MODEL	F20 Option Tray	VOLT/Hz	DATE OF MODIFICATION	SERIAL NO.
MODIFIED ARTICLE	Parts Catalog			
REASON OF MODIFICATION	Parts Catalog Correction

CONTROL NO.	BRAND	CODE	V / H Z	SERIAL NUMBER / MODEL CODE			
				F 2 0 Option Tray			
1	R I C O H	- 1 7	115/60				
	R I C O H	- 2 7	220/50				
MODEL NAME				R T 2 0

1. PAPER CONVEYOR UNIT (Page 5-4)

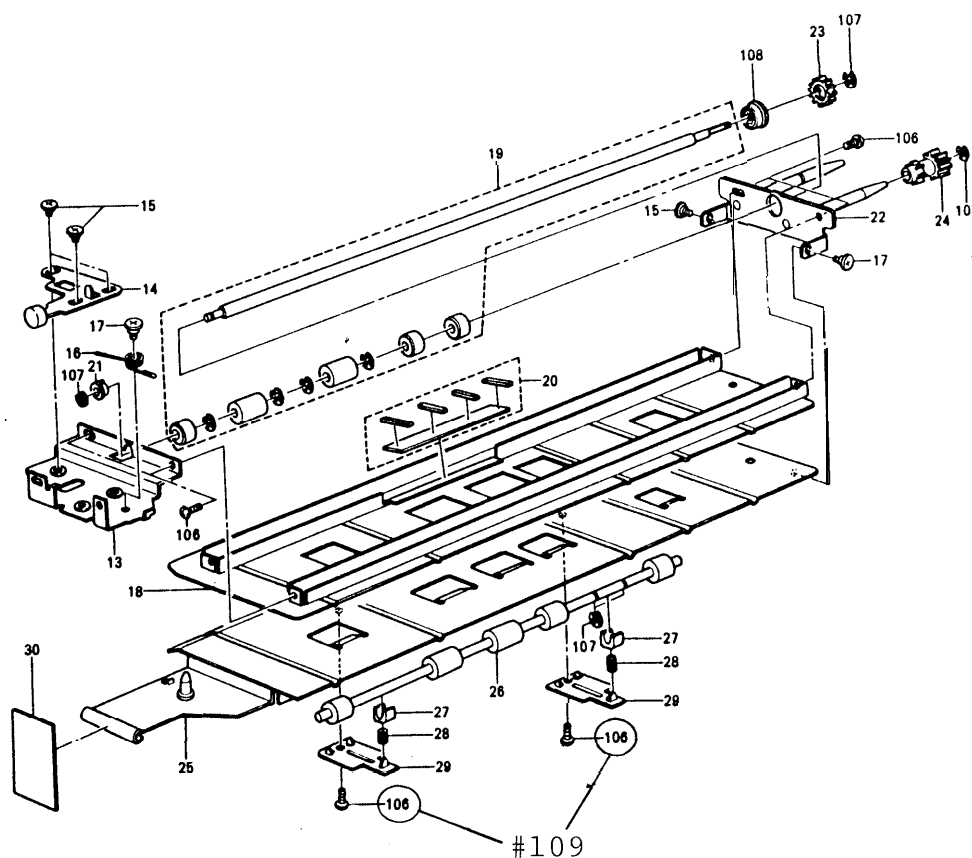
The philips screws #09514006W) were not listed on page 5-4, Please correct the index numbers accordingly

Description	Q'ty	Index No.	Page
09514006W Philips Screw With Flat Washer - M4x6	2	*109	5-5

4. EXTERIOR 2 (Page 5-10)

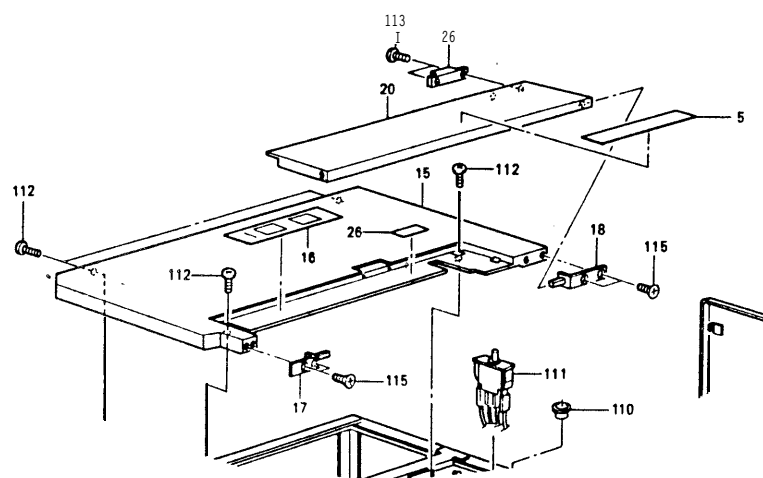
Since the superfluity between the access cover and safety switch is insufficient, the safety switch is sometimes turned off by vibration. SO, the misfeed indicator is displayed on the operation panel and monitor PCB.

To ensure setting between the above two parts, the seal(#59382952) between the top cover and magnet of the access cover has been deleted.

3. EXTERIOR 1 (Page 5-8)

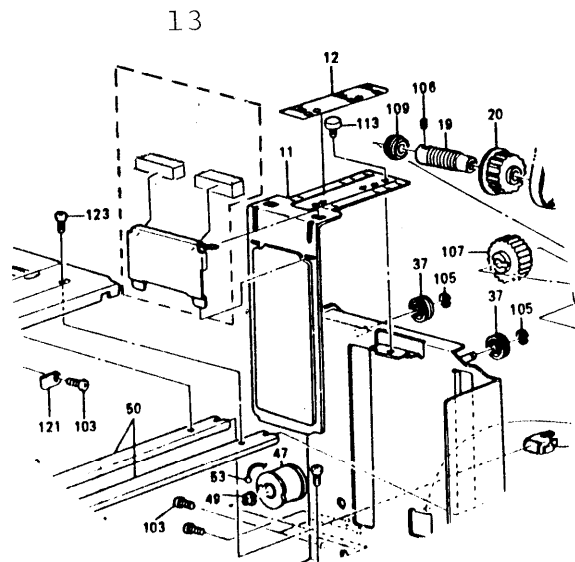
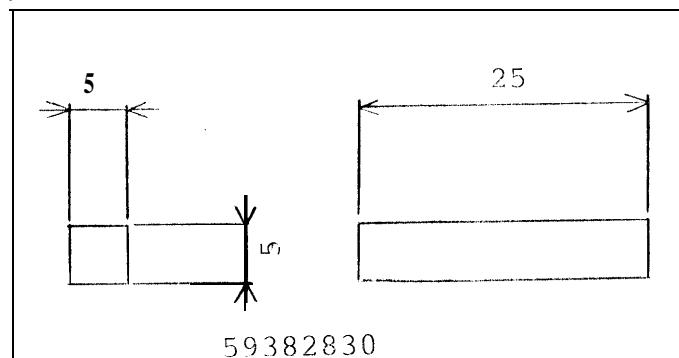
To increase safety, the guard rubber has been added in the plate spring of the side fence. The number of the plate spring has been changed to the number including the guard rubbers.

1. PAPER CONVEYOR UNIT (Page 5-4)

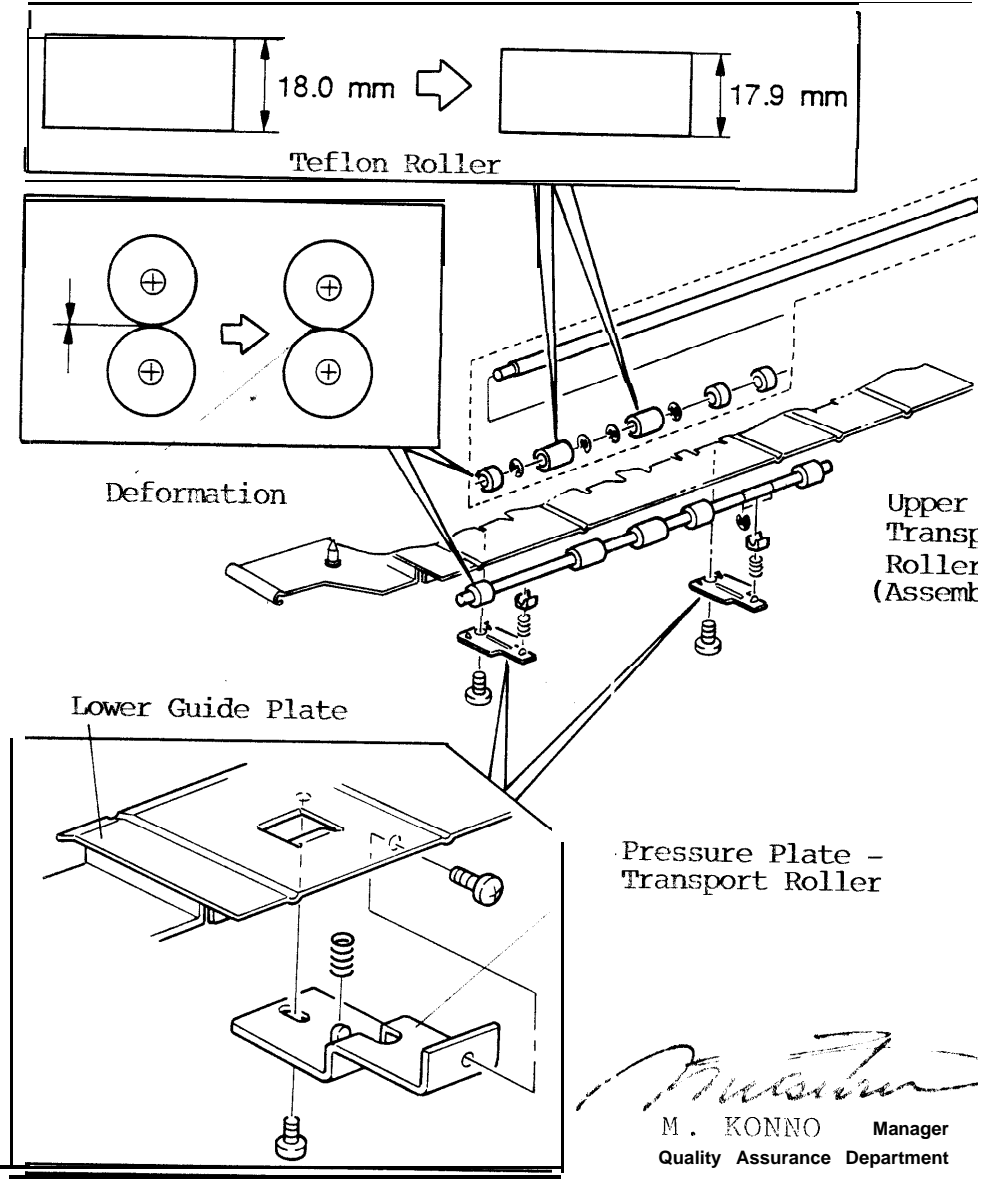
To improve transportability of the transport rollers in the F20 option tray, the following modifications have been applied to the production line.

1. **Pressure Plate - Transport Roller**
These plates apply pressure between the upper and lower transport rollers. To maintain sufficient pressure, the securing screws of each plate have been increased from one to two.
2. **Lower Guide Plate**
Although the part number has not been changed, two screw holes have been provided to install the above additional screws..
3. **Upper Transport Roller (Assembly)**
This roller assembly consists of two teflon rollers and three rubber rollers. The diameter of each teflon roller has been decreased from 18.0 mm to 17.9 mm increasing the deformation of the rubber rollers. This accordingly further improves the paper transportability of the transport rollers.

NOTE: A slight deformation in rubber feeding rollers increases the contact area resulting in more efficient paper transportability.

1. PAPER CONVEYOR UNIT (Page 5-4)

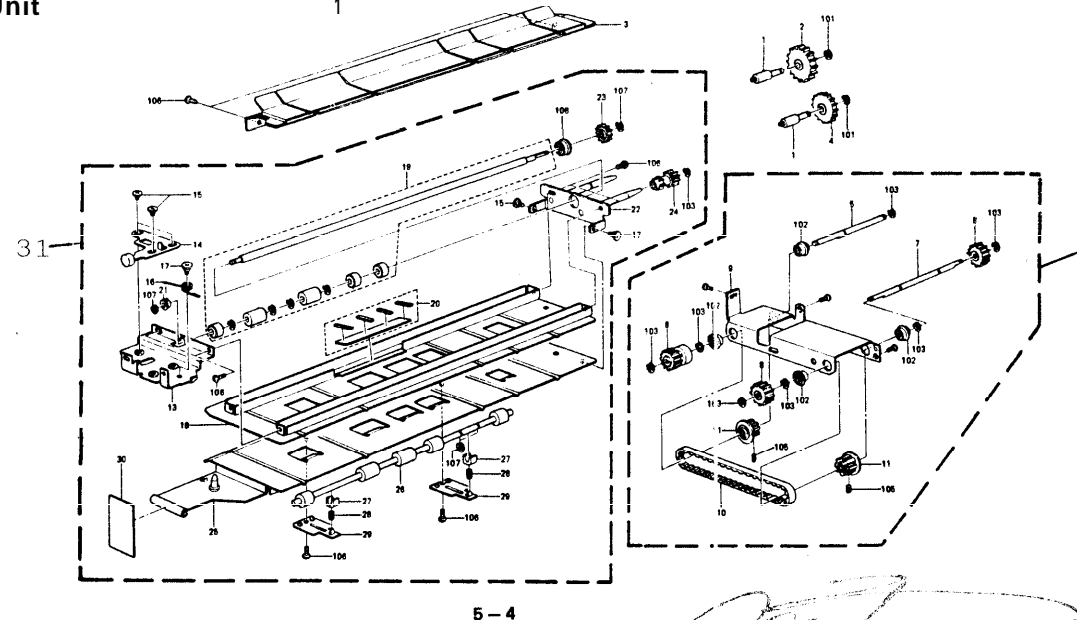
Please circle the above units in your parts catalog as follows

Page	Index No.	Part Number	Description	Q'ty
5-5	31 (New Index)	#59382550	Paper Conveyer Unit	1
5-5	32 (New Index)	#59382600	Paper Conveyer Drive Unit	1

3. EXTERIOR 1 (Page 5-8)

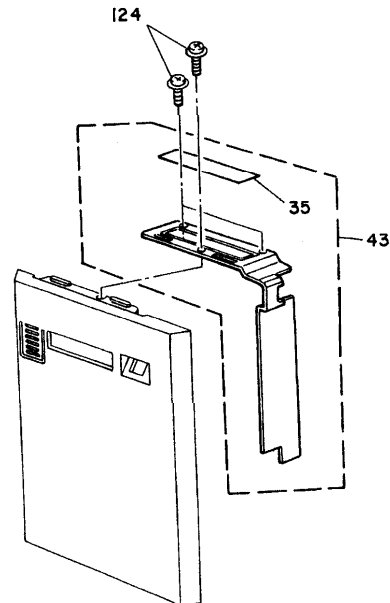
Please correct the following part and illustration in your parts catalog:

Page	Index No.	Incorrect P/N	Correct P/N	Description	Q'ty
5-9	43	#59382704		Upper Cover	
5-9	43		#59387010	Drawer Upper Cover

8. DECAL AND DOCUMENT (Page 5-18)

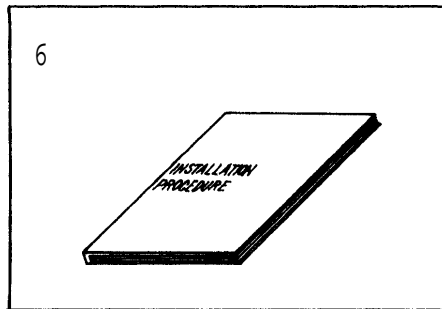
Please add the following part and illustration to your parts catalog:

Page	Index No.	Part Number	Description	Q'ty	
5-19	6 (New Index)	#59388721	Installation Procedure - English	1	(Ricoh version)
5-19	6 (New Index)	#59388722	Installation Procedure - Multi	1	(Ricoh version)
5-19	6 (New Index)	#59388723	Installation Procedure - English	1	(OEM version)

4.EXTERIOR 2 (Page 5-10)

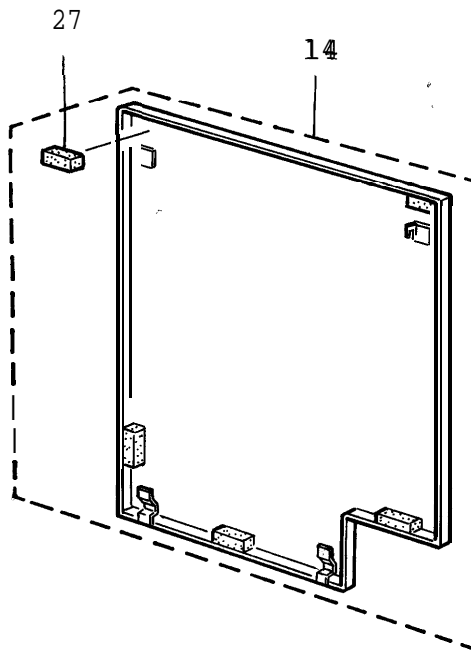
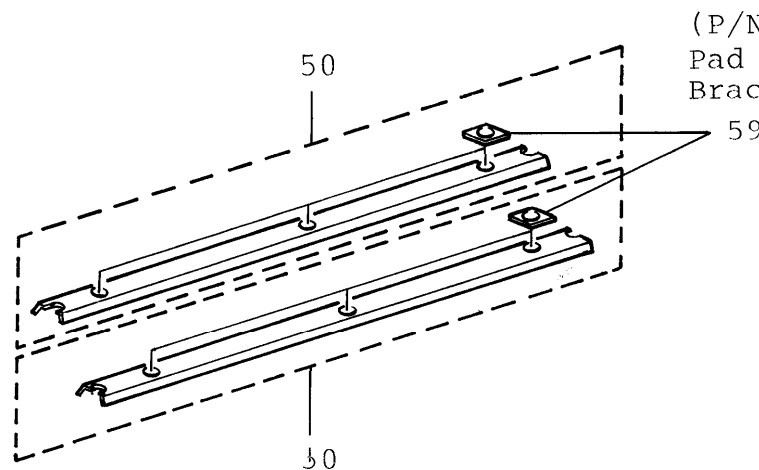
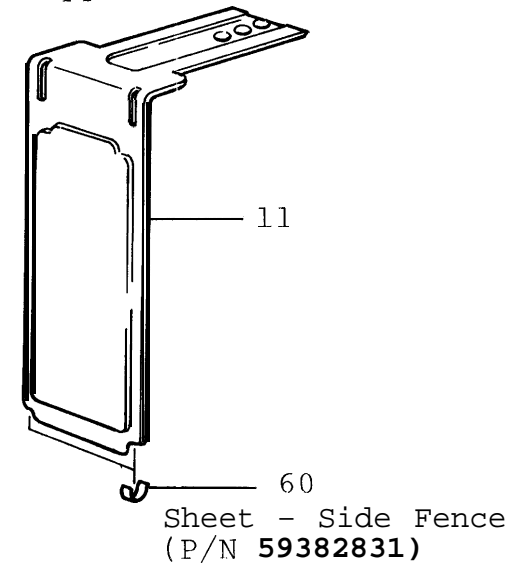
To decrease vibration noise of the option tray when the drawer feed plate moves up or down, six rubber stoppers have been adhered onto the rear cover, three pads each have been adhered on two tray support brackets, and two mylar sheets have been adhered underneath the side fence bracket.

1. PAPER CONVEYOR UNIT (Page 5-4)2. PAPER FEED UNIT (Page 5-6)

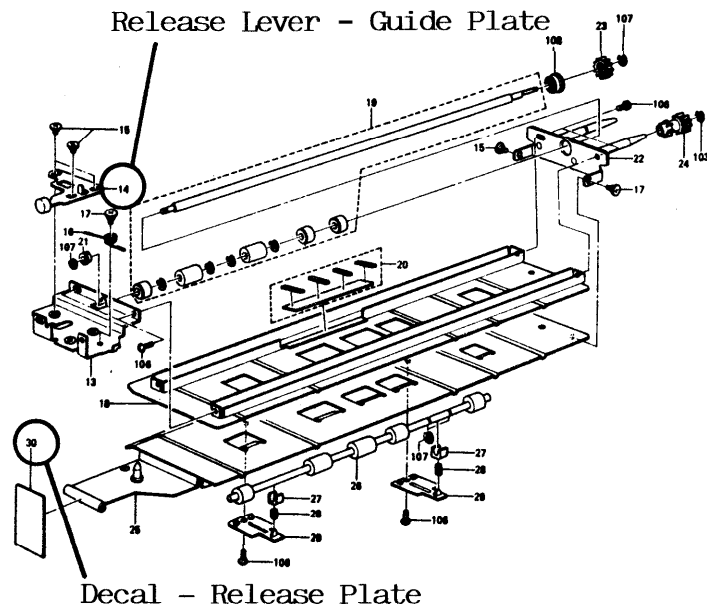
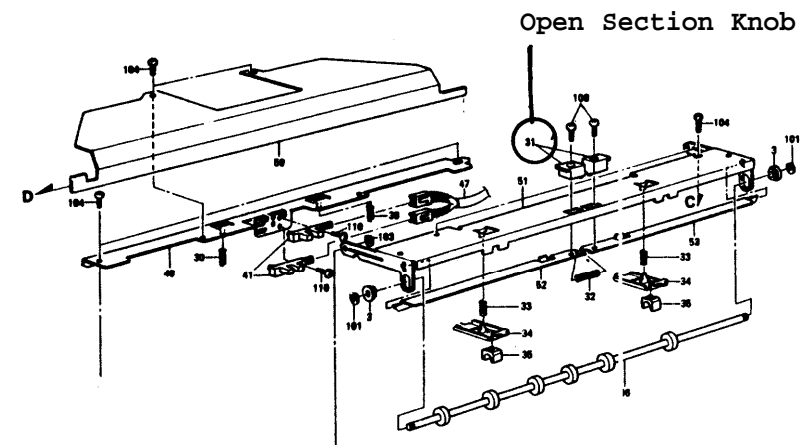
In the Pitney Bowes, Savin, and Nashua version machines, the large capacity tray for the F20 will be commonly installed onto the F21. As per color standardization with the F21, the color of the modified parts described in page one and two of this bulletin has been changed.

4.EXTERIOR 2 (Page 5-10)

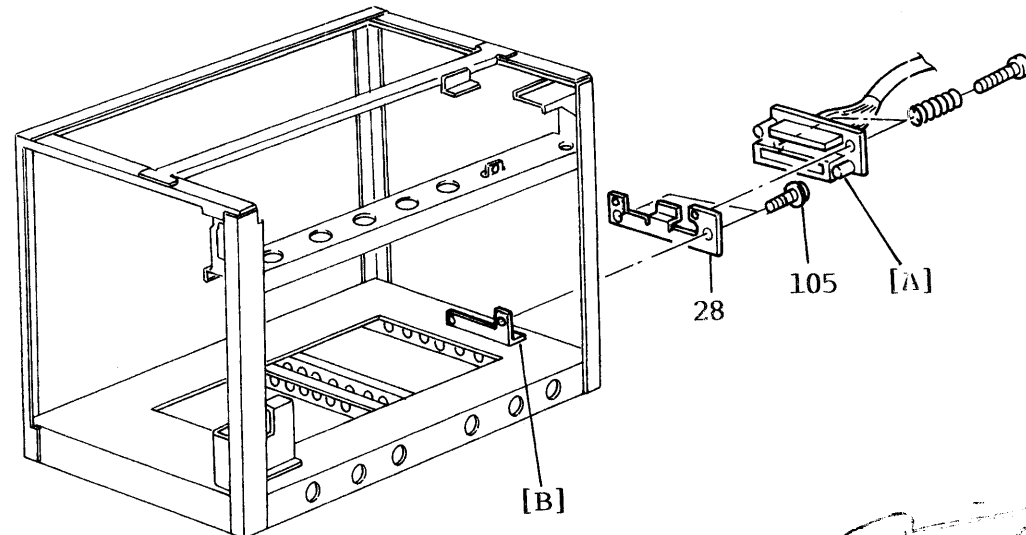
The connector [A] of the option tray harness is sometimes broken by pulling out and pushing in the paper tray drawer repeatedly.

As a result, the paper tray drawer cannot be pushed in or the paper end indicator remains on. Therefore, the connector bracket has been added between the connector and the frame.

NOTE: The shape of the frame [B] has also been changed. However, the frame is not a service Part. Thus, the connector bracket cannot be installed onto the machines which have been produced before the serial number mentioned on Page 3 of 3.

2. PAPER FEED UNIT (Page_ 5-6)

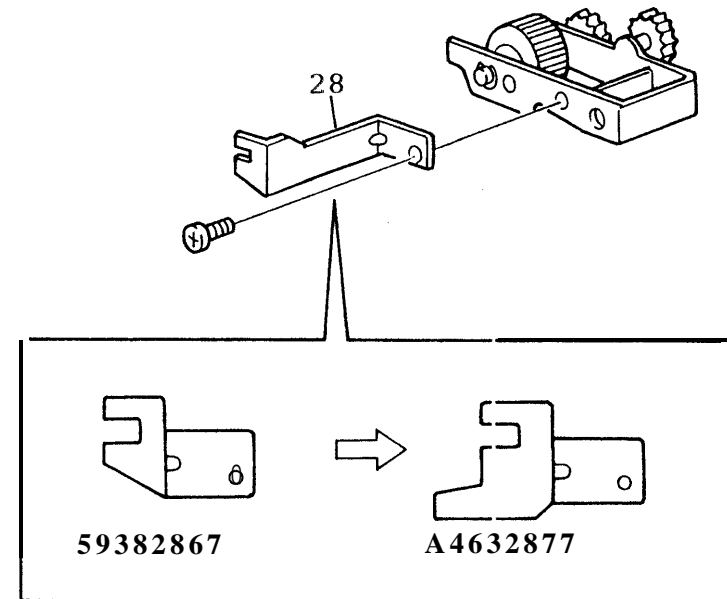
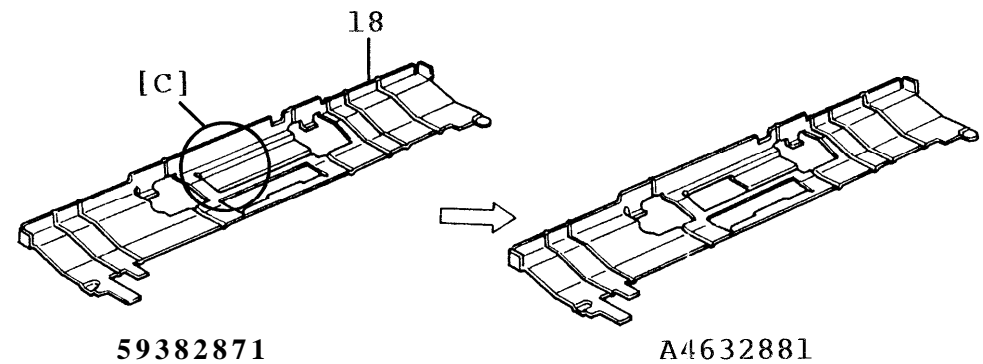
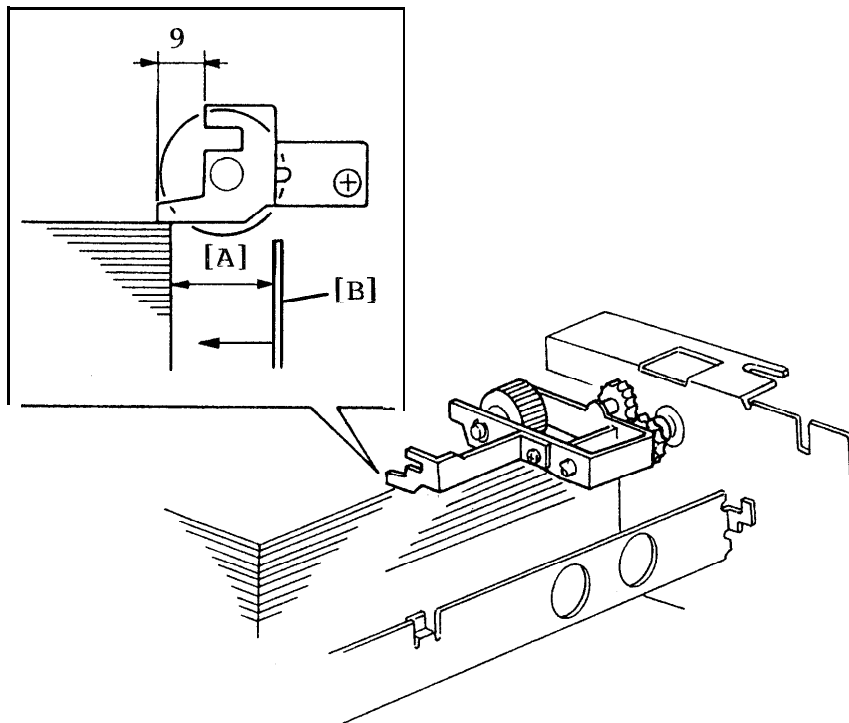
When the paper is not loaded at the proper position on the large capacity tray, the tray overruns and then the drive wire may be cut. Therefore, the shape of the upper volume sensor actuator has been changed as shown in the illustration. As a result, the upper volume sensor has been able to detect the paper which is loaded within 22 mm [A] from the right side plate [B]. However, when the paper is loaded between 12 mm and 22 mm from the right side plate, paper misfeed occurs in the paper feed section.

Due to the change of the upper volume sensor actuator, a part [C] of the upper guide has been cut off to prevent the actuator from coming into contact with the upper guide.

NOTE: When the upper sensor actuator is replaced with the new one, please replace the upper guide at the same time.

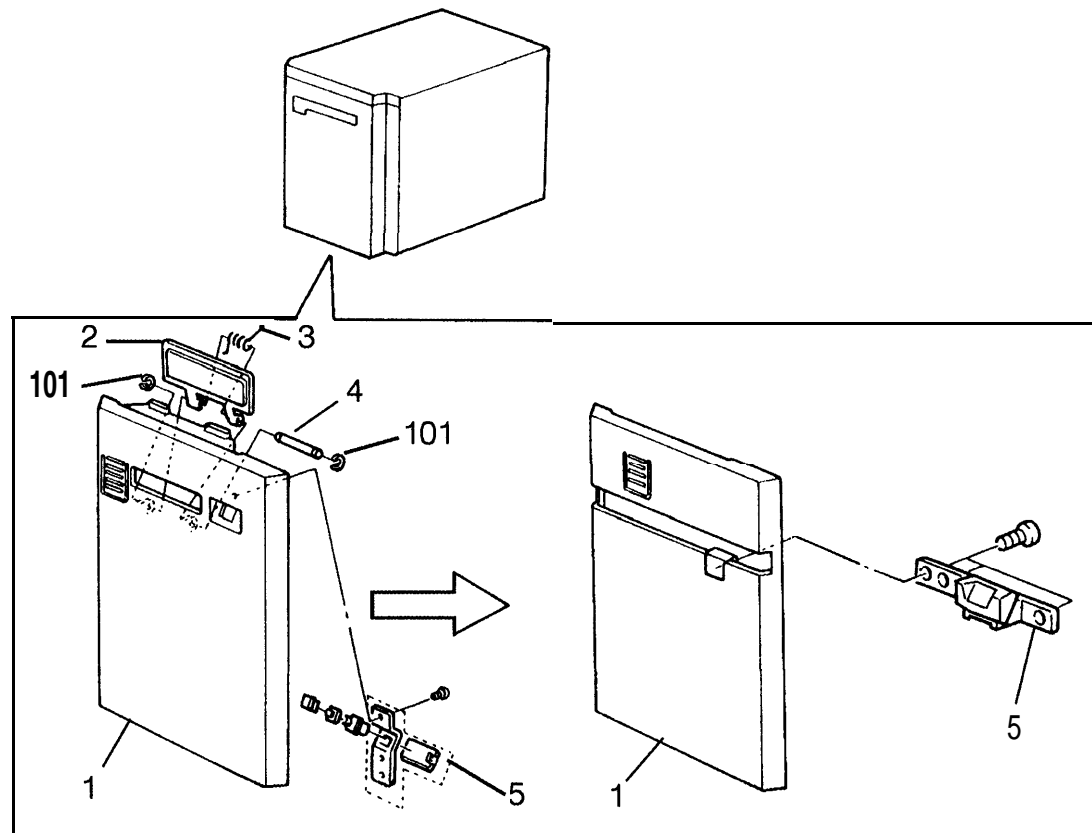
To make the look of the LCT compatible with the F22, the design of the front cover and the tray button switch have been changed, but the old LCT can also be used on the F22.
